Addendum No. 01

Subject: Emlen Classroom Modernization Project

B-031C, B-032C, B-033C of 2018/19

Location: Eleanor C. Emlen Elementary School

BASEMENT ELECTRICAL PLAN
E100 SCALE: 1/8" = 1'-0"

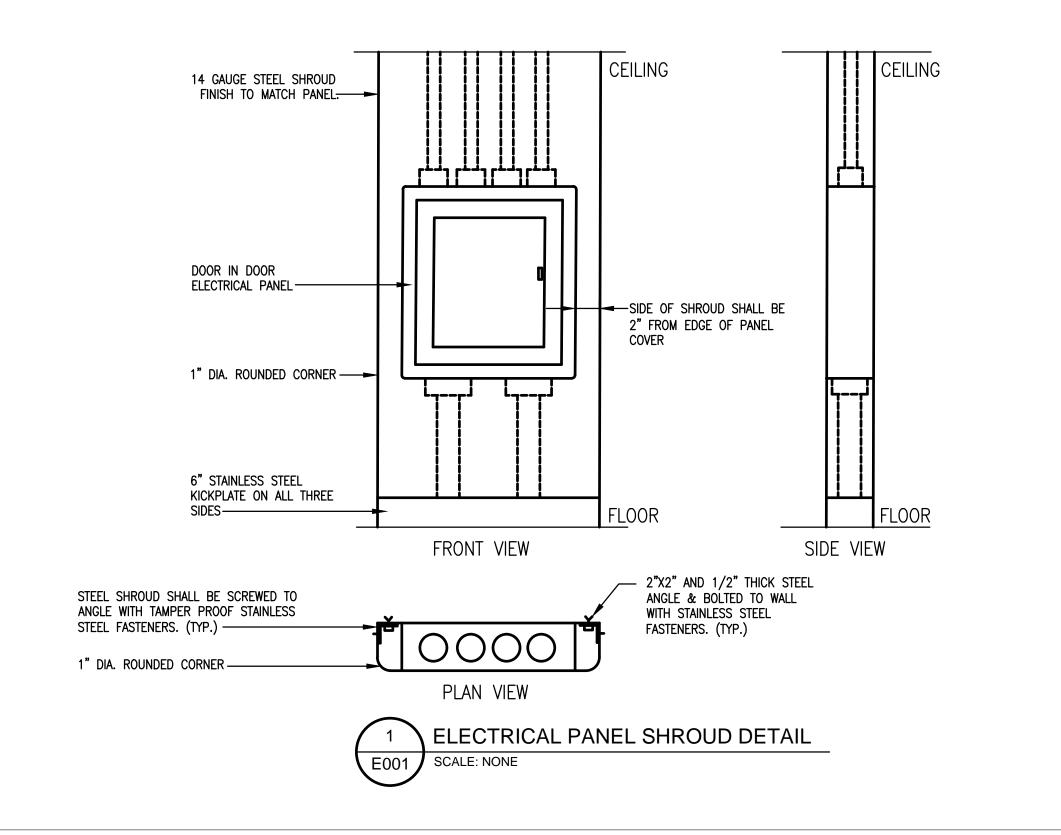
For changes see drawing E100.0 Rev1 dated 2/22/19 as issued with this Addendum.

FIRST FLOOR POWER &

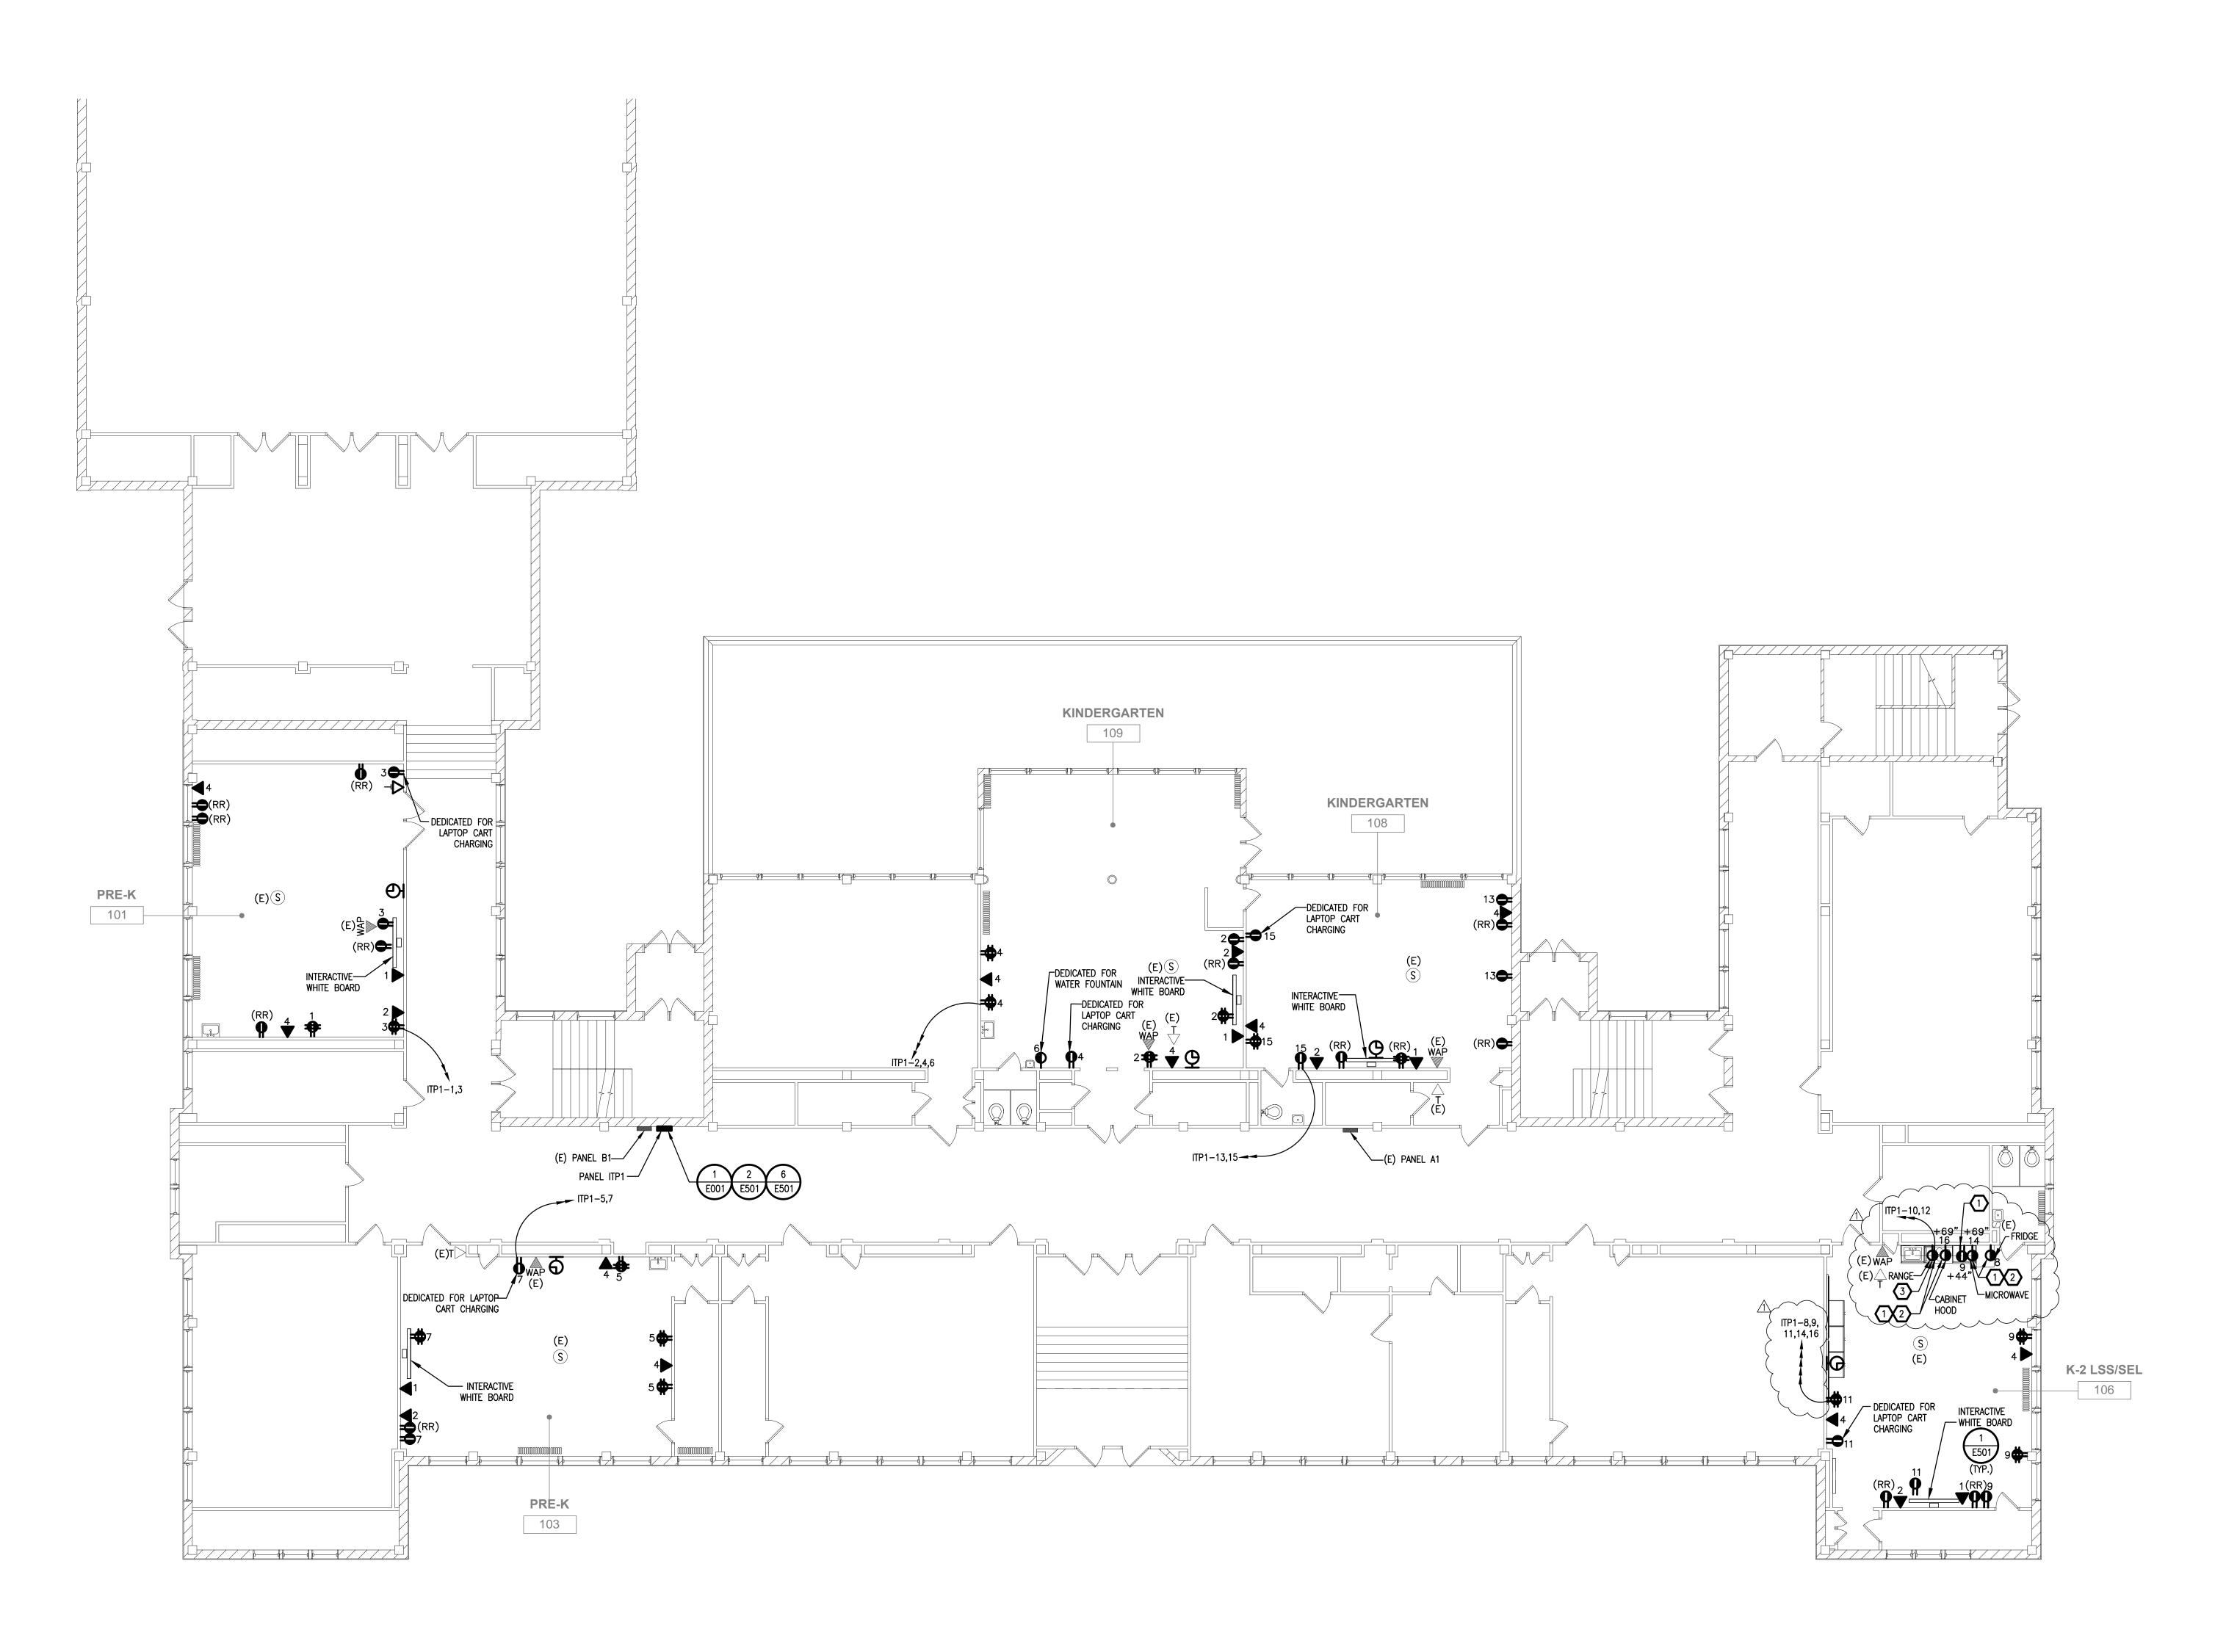
For changes see drawing E101.0 Rev1 dated 2/22/19 as issued with this Addendum.

COORDINATE POWER AND WIRING REQUIREMENTS WITH MANUFACTURER'S RECOMMENDATIONS.

COORDINATE LOCATION OF RECEPTACLE IN FIELD.

RECEPTACLE SHALL BE SUITABLE FOR 50A, 125/250V, 3 POLE, 4 WIRE, GROUNDING NEMA 14–50R.
